L-MT-23-035  
10 CFR 54.17

Monticello Nuclear Generating Plant  
Docket No. 50-263  
Renewed Facility Operating License No. DPR-22

Subsequent License Renewal Application Supplement 5

Figure 3.5.2.2.2.6-1: Section Through Monticello Biological Shield Wall

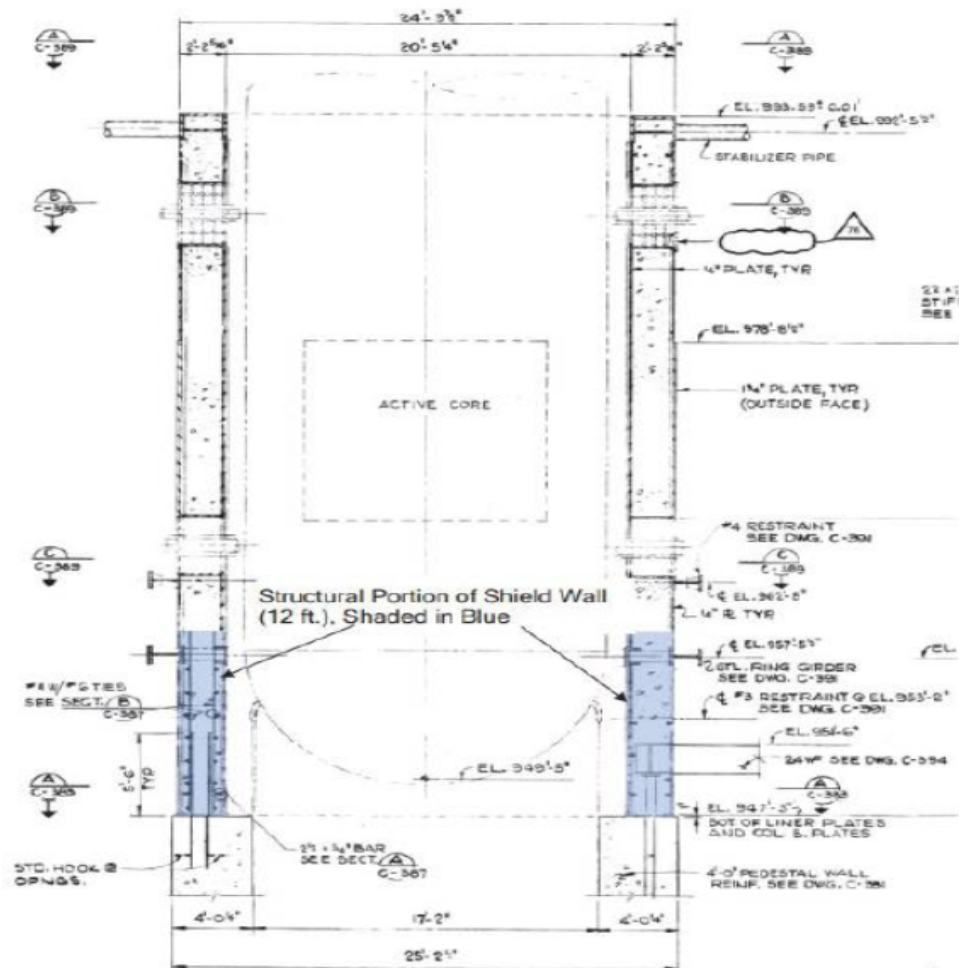
A narrative to explain the corresponding locations for the bounding fluence and gamma dose is being added. A figure that includes shading to show the region of bioshield concrete that is considered in further evaluation section 3.5.2.2.2.6 for the effects of irradiation is also being added to the SLRA. A summary of the methodology and conclusions in calculations supporting the effects of radiation on the biological shield/pedestal concrete and RPV steel supports is also added.

The portion of the biological shield directly across from the active core will receive the maximum irradiation, which drops off significantly above and below the core. Irradiation effects on the biological shield concrete, the biological shield structural steel, and reactor vessel support structure inside the reactor cavity are evaluated below. **The evaluation starts with determining the cumulative neutron fluence and gamma dose in reactor cavity locations at 72 effective full power years (EFPY). Those values are then used in evaluating the strength and mechanical properties of the bioshield concrete. The values and associated displacements per atom (dpa) are also used regarding the potential irradiation embrittlement (ductility reduction) of the biological shield structural steel, including seismic restraints, and of the reactor vessel support structure, which comprises a steel and concrete pedestal, well below the height of the active fuel.**

**The location of the bounding 72 EFPY fluence and gamma dose corresponds roughly to the core mid-plane. Figure 3.5.2.2.6-1 shows the elevation of structural concrete relative to the core and core mid-plane.**
